Project Name: Electric Light Building Addition

Project Description: 48 X 125' garage/shop addition to existing structure
with site improvements including landscape buffers
and drainage.

York Planning Board
Brendan Summerville, Town Planner
Town of York
186 York Street
York, Maine 03909

Subject: Review of Post Construction Stormwater Inspection & Maintenance Plan for Electric Light Company, 1 Morgan Way, Cape Neddick, Maine 03902 Map 99 Lot 044

Exhibit 1 Plan Sheet 3

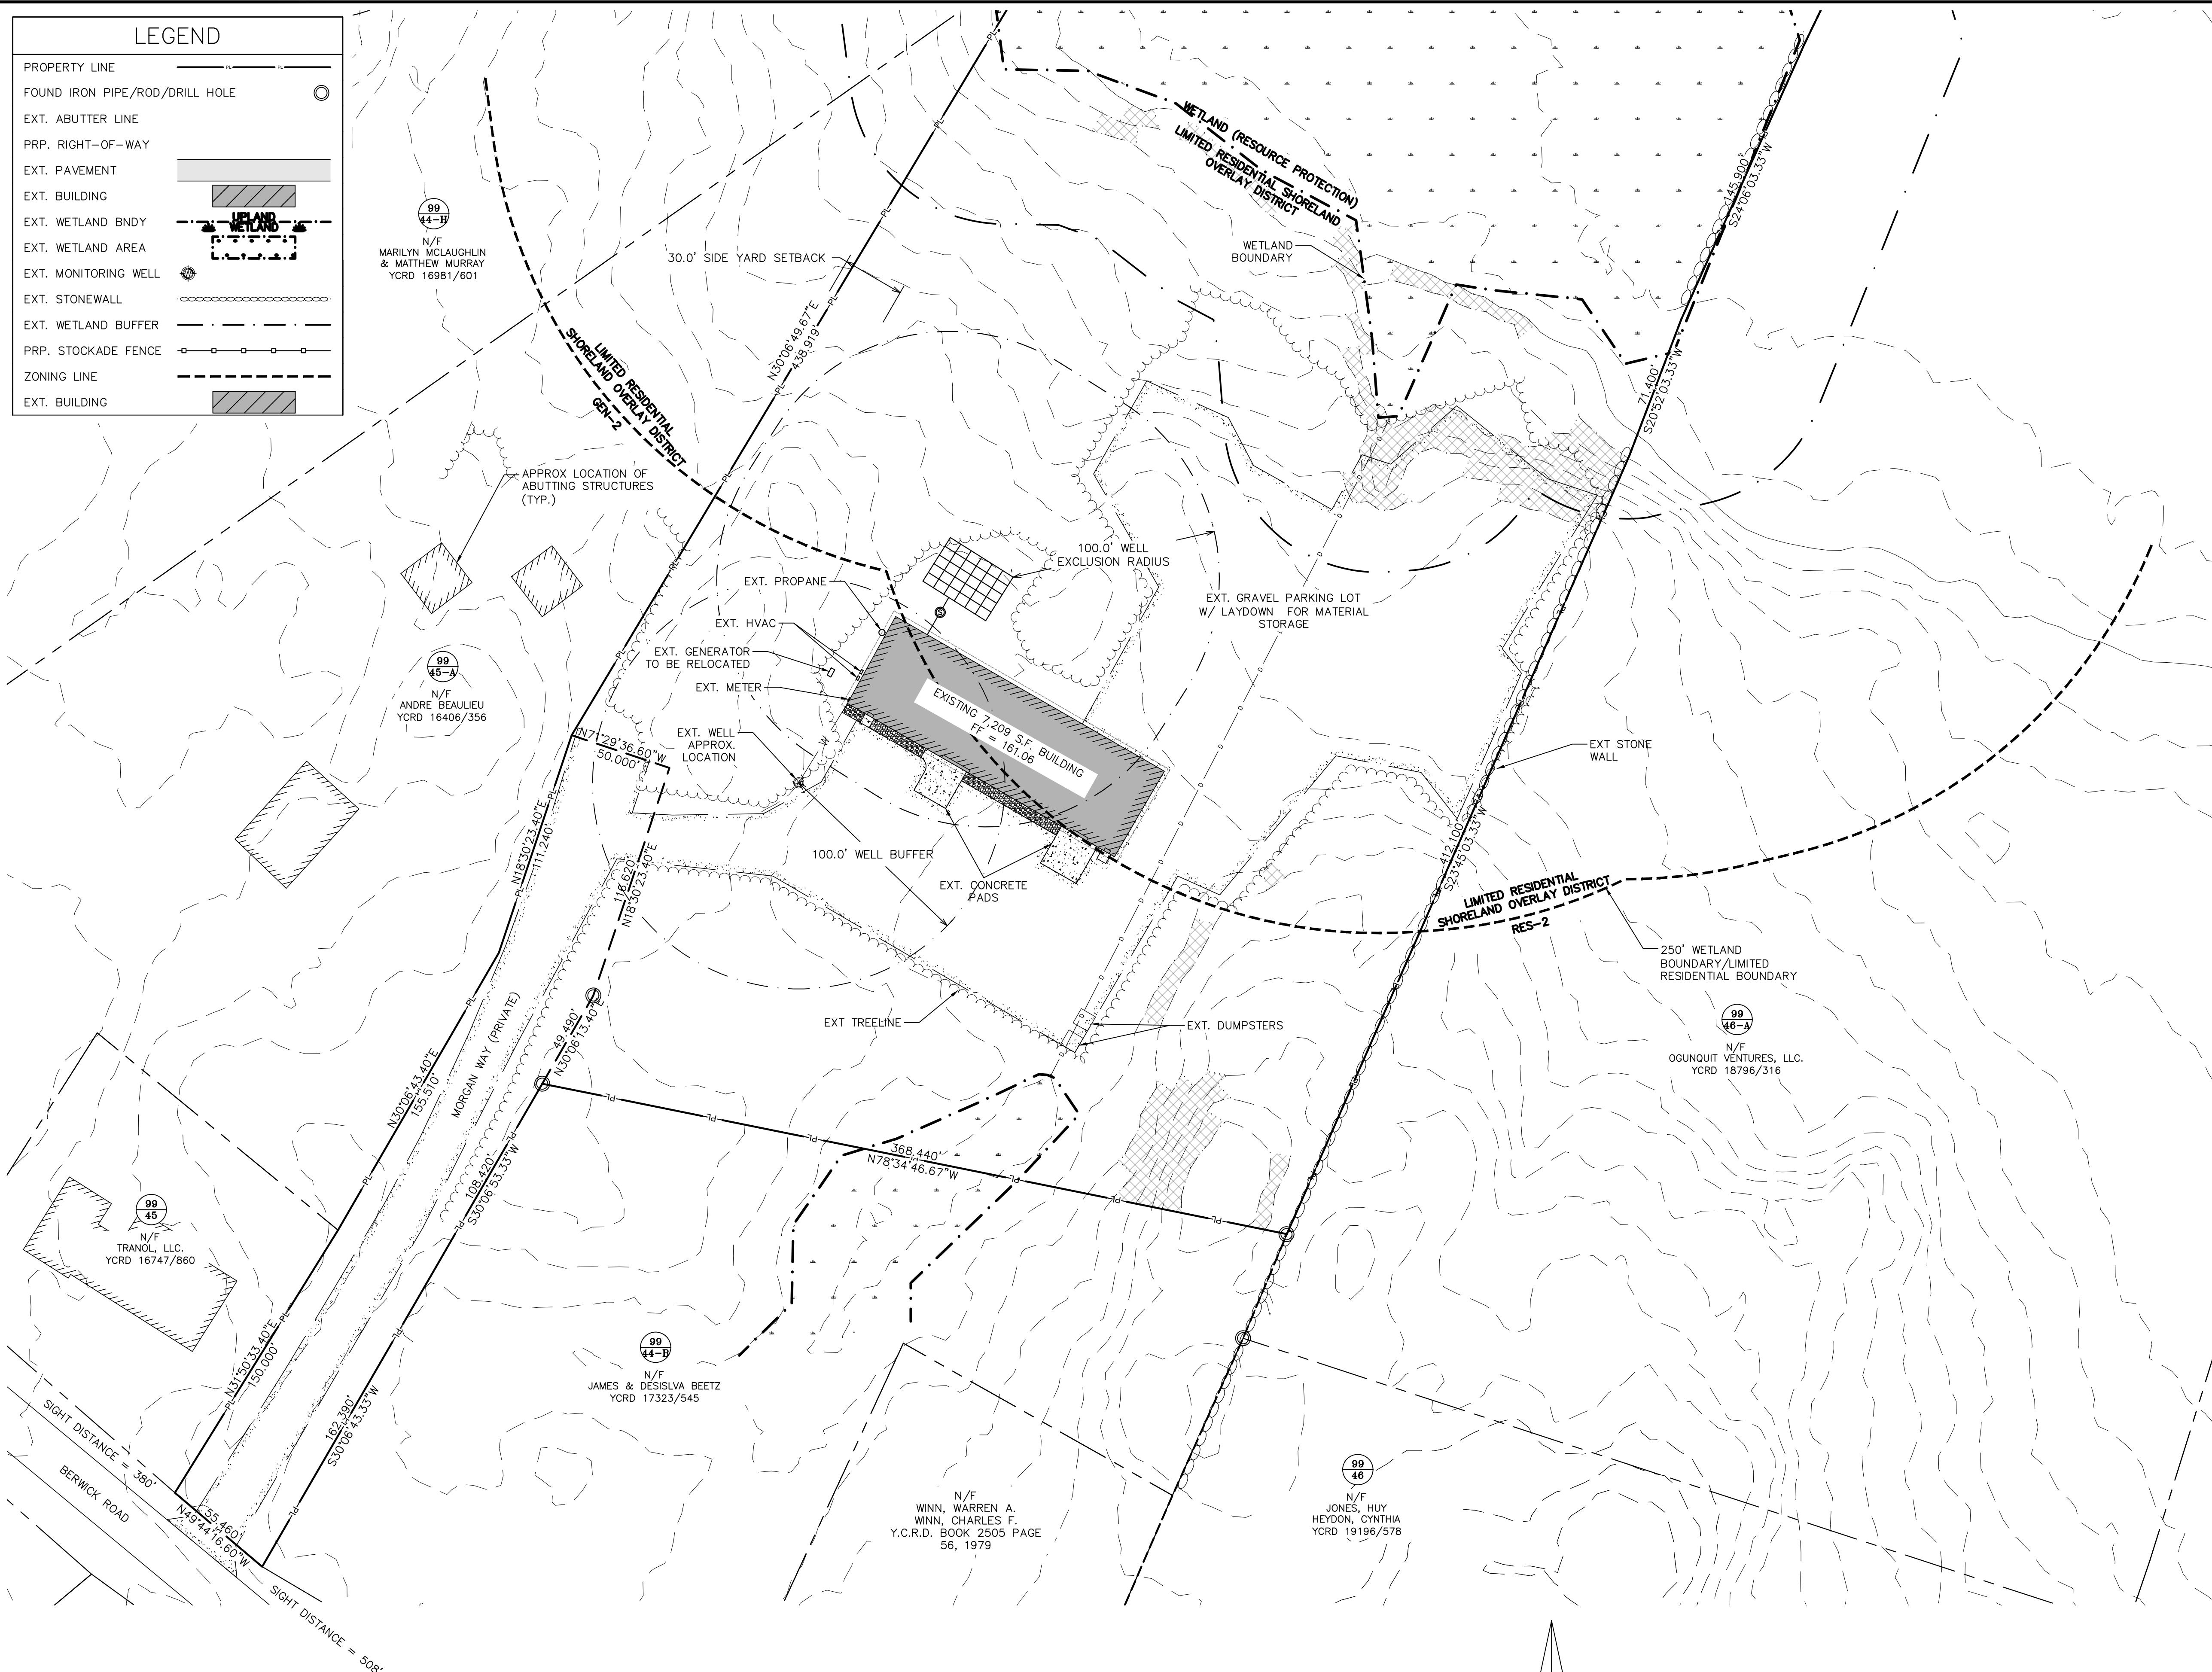
6. Demonstration of total impervious surface ratio and coverage is not entirely clear and needs further clarity and information. **The plans have been revised. The additional calculations, however, (Plan Note 5 on sheet 2) are not clear. (see comment 2.b below)**

b. In the GEN-2 zone there is a requirement not to exceed 25% impervious surface ratio for the lot. [and 20% for the area within the Shoreland Overlay Zone subdistrict Limited Residential per Article 8]. The plans (Sheet 2, Site Plan) appear to only include the buildings in the coverage calculations. See the Definitions section of the Zoning Ordinance for more information on calculating 'Impervious Surface Ratio'. The applicant has revised the plan, however, the calculations, (Plan Note 5 on sheet 2) reflect only gravel area for coverage (under 'PRP. SHORELAND..') and the note below states 'no additional impervious area' in the shoreland zone. The plans reflect approximately half the existing building within the shoreland zone, but the area doesn't appear to be reflected in the shoreland calculations. The riprap associated with the stormwater pond should be reflected in the total coverage amounts. The Applicant should confirm and revise accordingly.

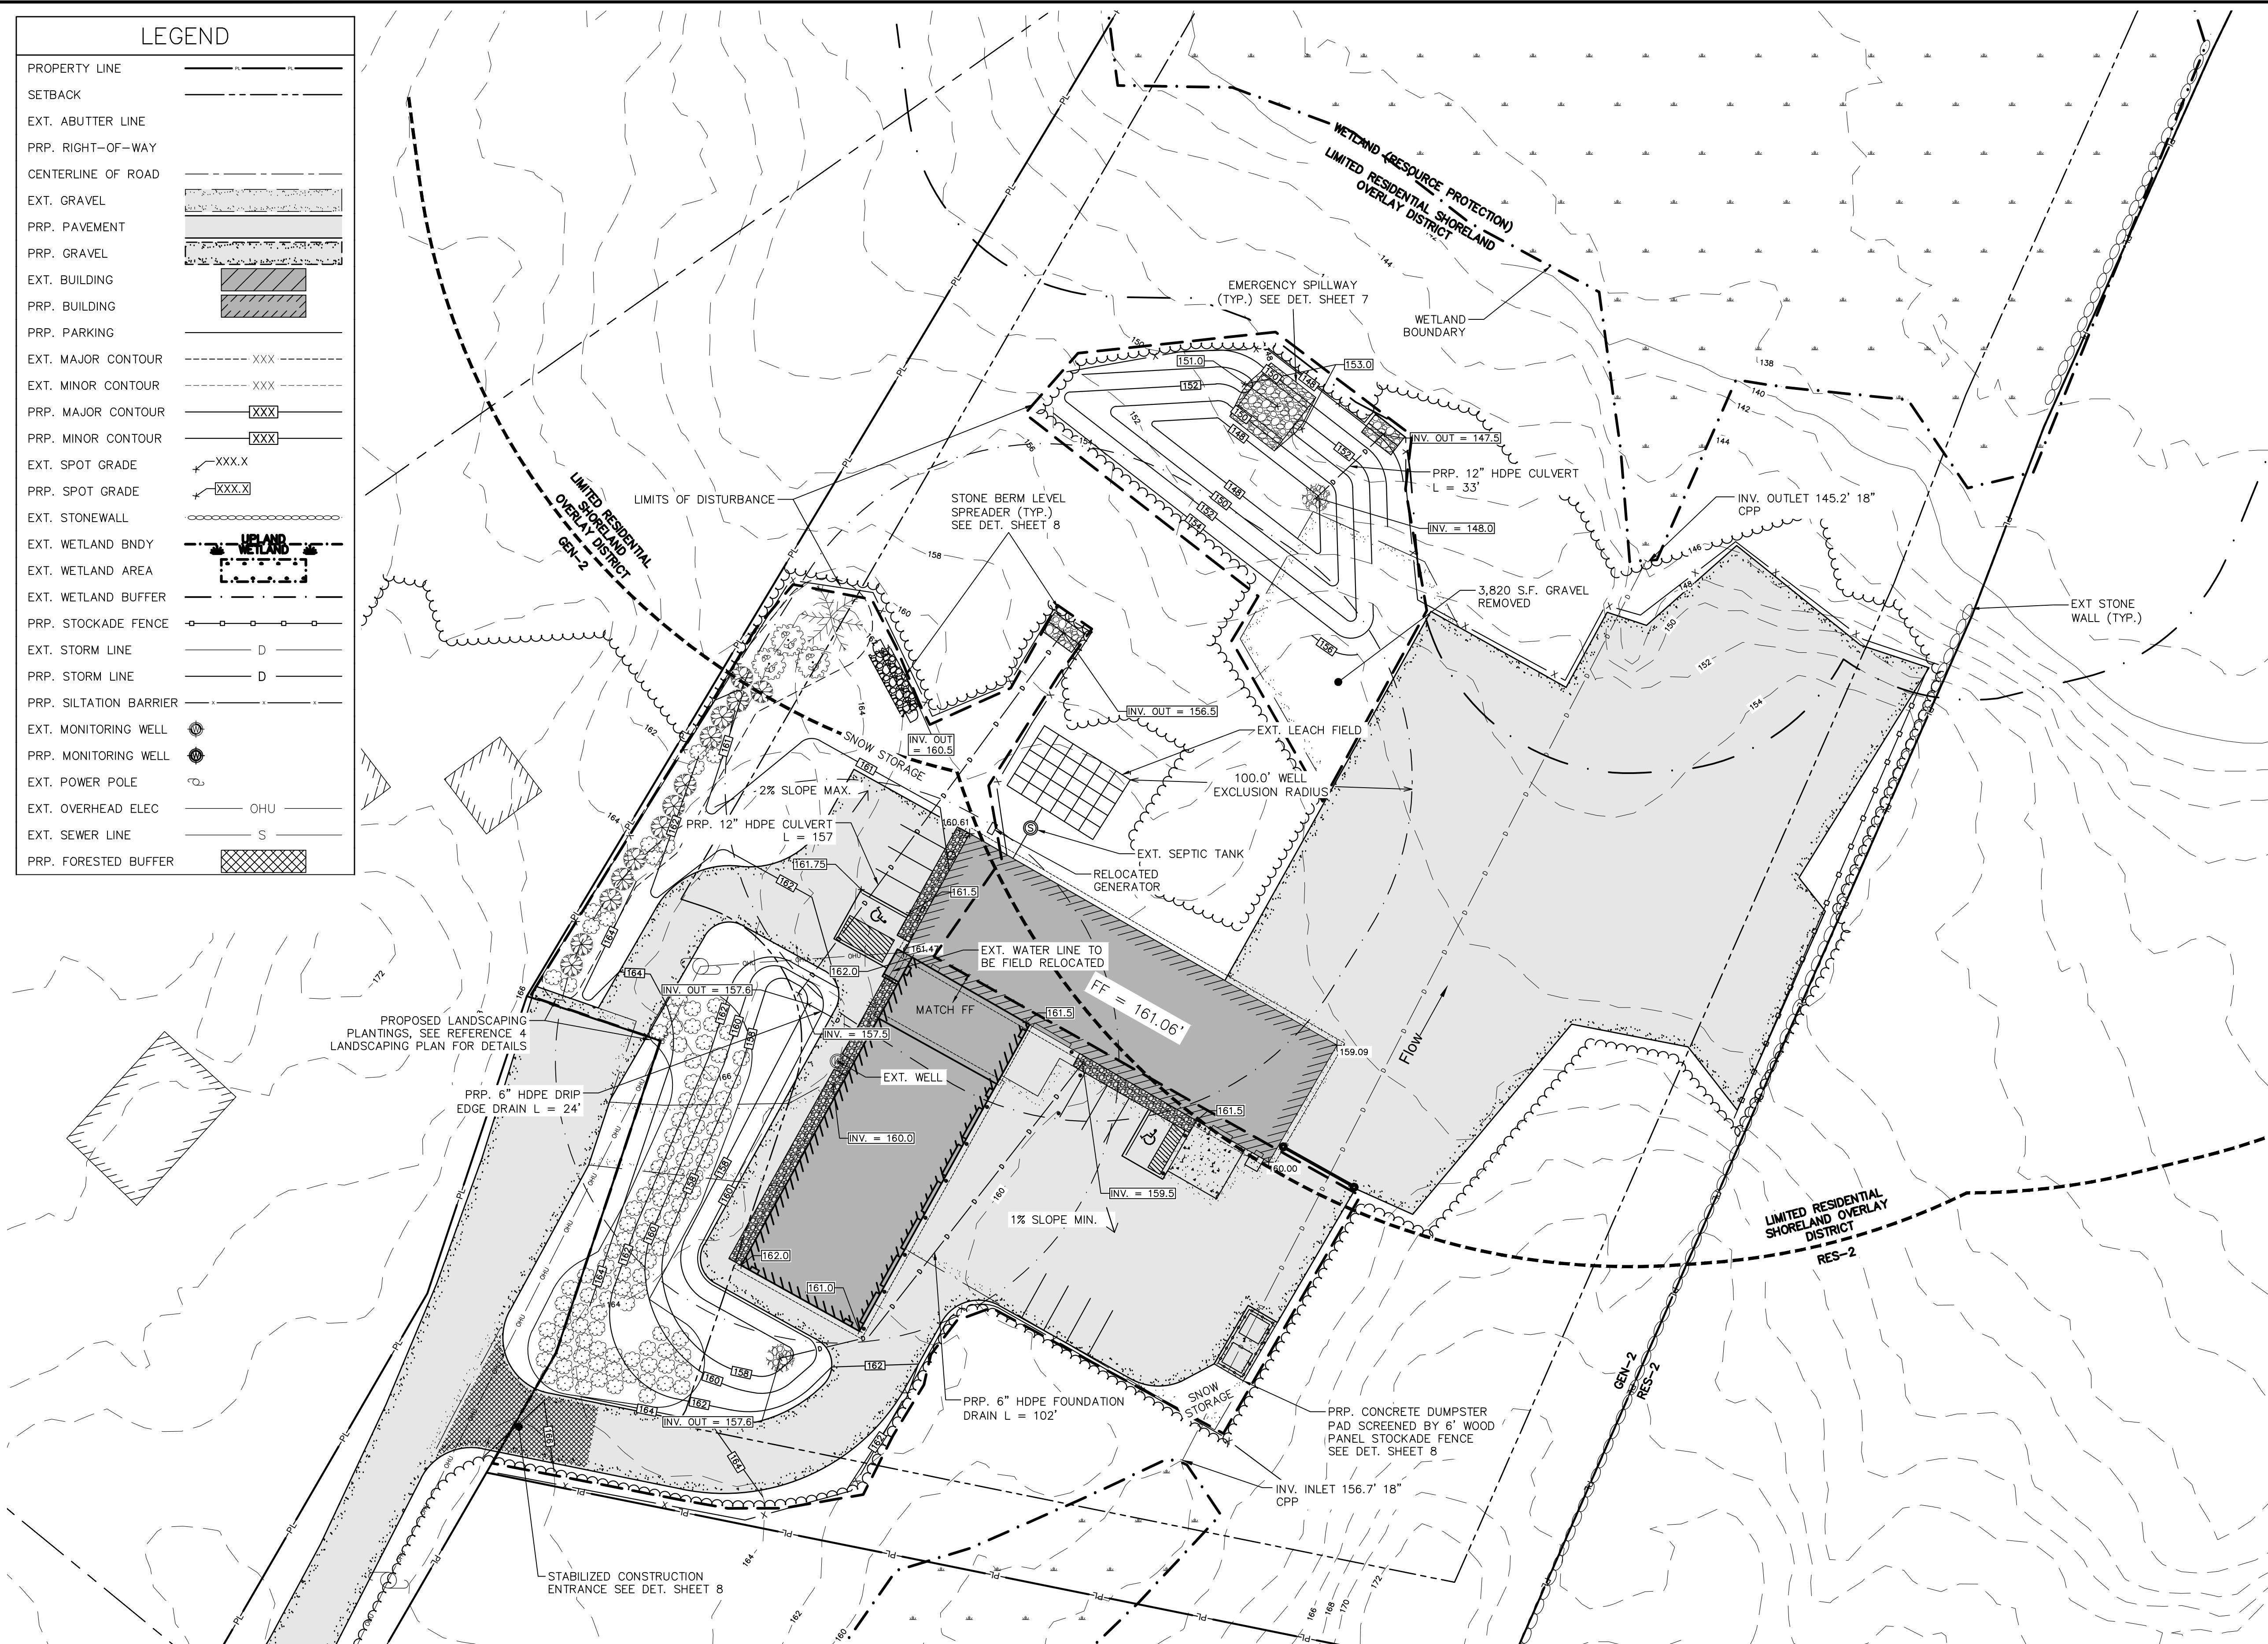
b. There appear to be three roof drip edges on the site as shown on the Grading and Utility Plan. Please clarify if the hydrocad analysis included all three lengths of drip edge.

e. The Town's Site Plan and Subdivision Ordinance was updated 2/23/2023 to require a note on the plan that the limit of disturbance will be visually delineated in the field prior to disturbance and a preconstruction meeting with code enforcement is required. The Town's ordinance also requires showing the limits of disturbance on the plans. Please add the limits of disturbance to the plans and add the note that limit of disturbance must be visually delineated in the field.

- This comment was addressed (2 new drip edges and one existing drip edge).

- This comment has been addressed on Sheet 4.
